INDESIT company

MTM1521VR/HA

F048057

General notes

51720G0 Exploded views

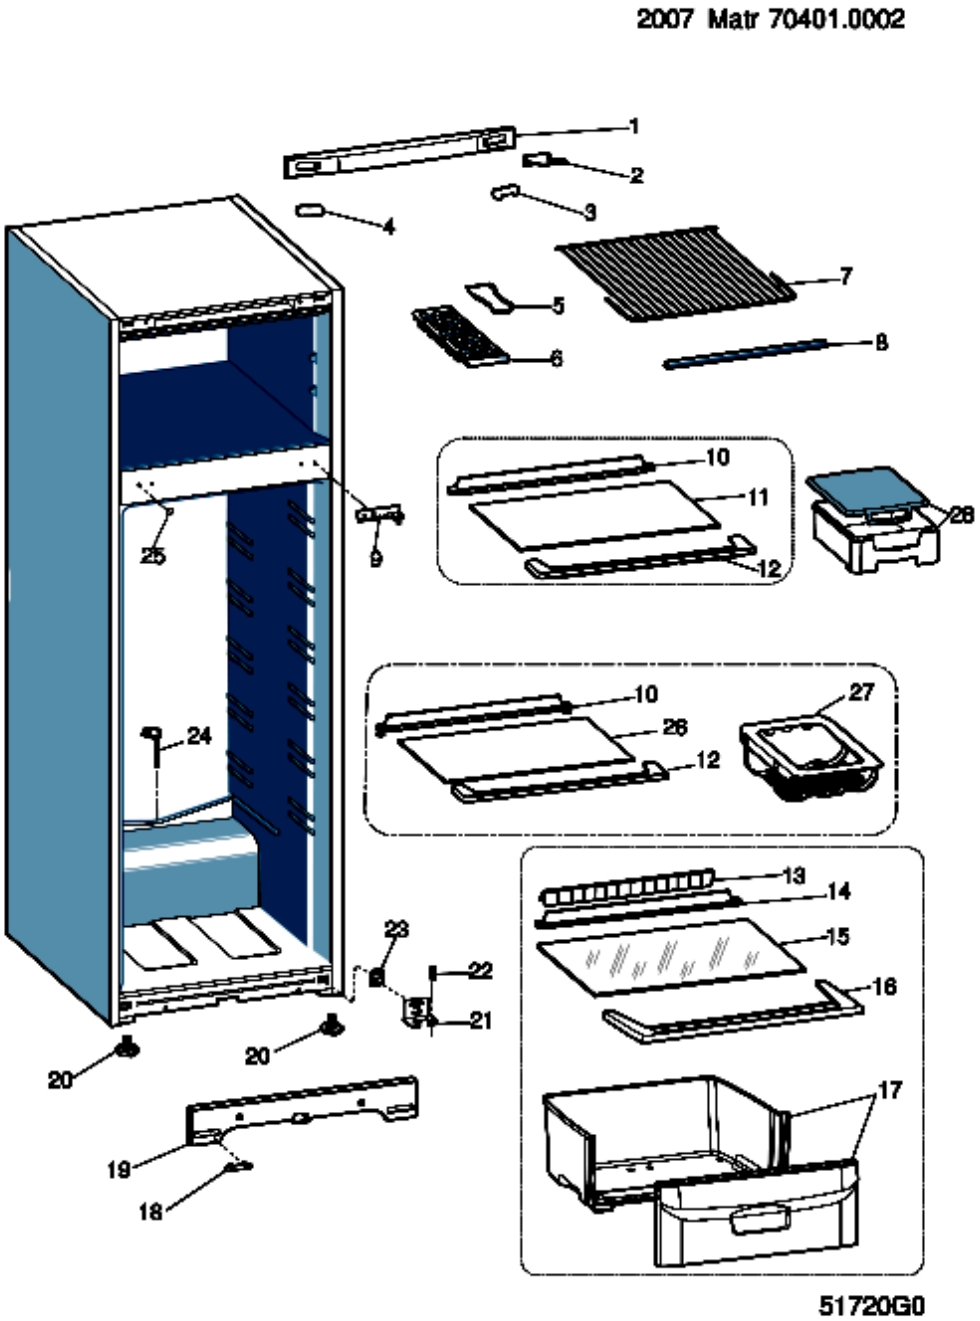
n2510j00: SUBSTITUTION LOWER HINGE PIN

In order to make better the assembly and to prevent an accidental unscrewing of lower hinge pin with consequent falling down of the door, original pin has been substituted by another one longer.

In the course of the time more than one pin has been tested, therefore the history of the substitutions is reported:

C00017658 (13.5mm) --> C00259768 (21mm) --> C00281425 (23mm)

For quality issues on interested models is managed only the last one C00281425 (23mm).

51721C0 Exploded views

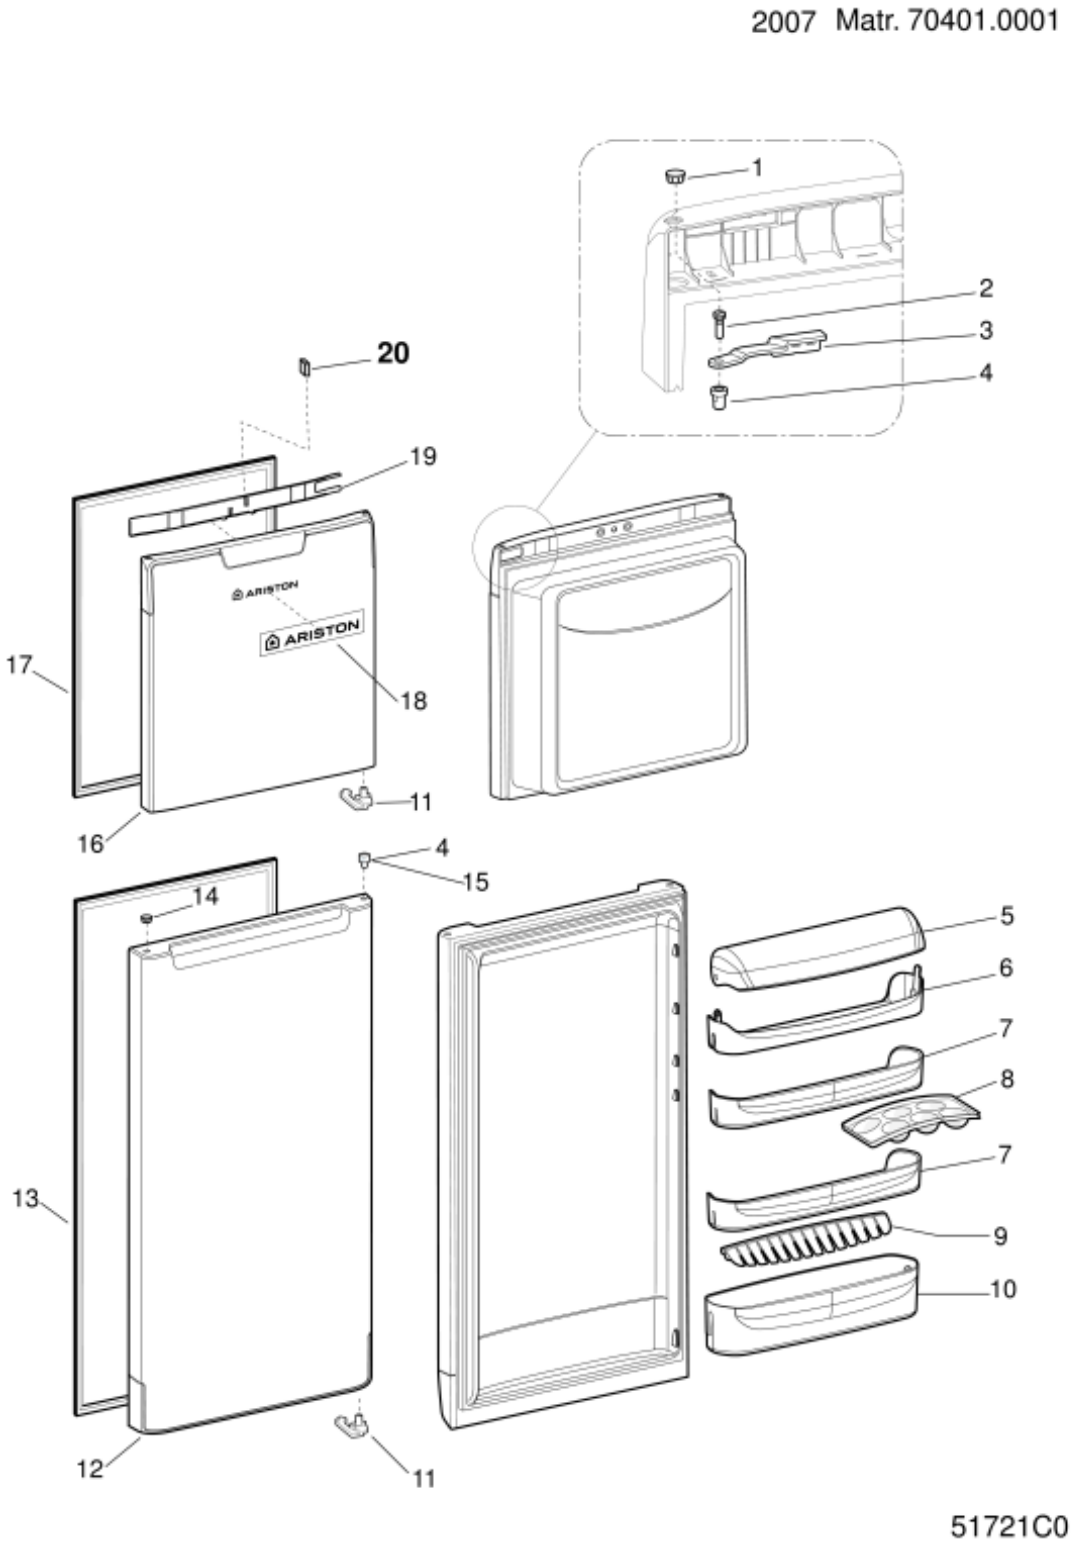
n2512f02: DOORS CHANGE

Original doors are not longer available so it will be necessary to substitute them with a new couple of equivalent doors: NEW doors have a DIFFERENT AESTHETICS. The engineer need the DOOR CONVERSION KIT C00291892 to apply them to the product.

New door codes to order are:

C00290214 FG
C00290213 FZ
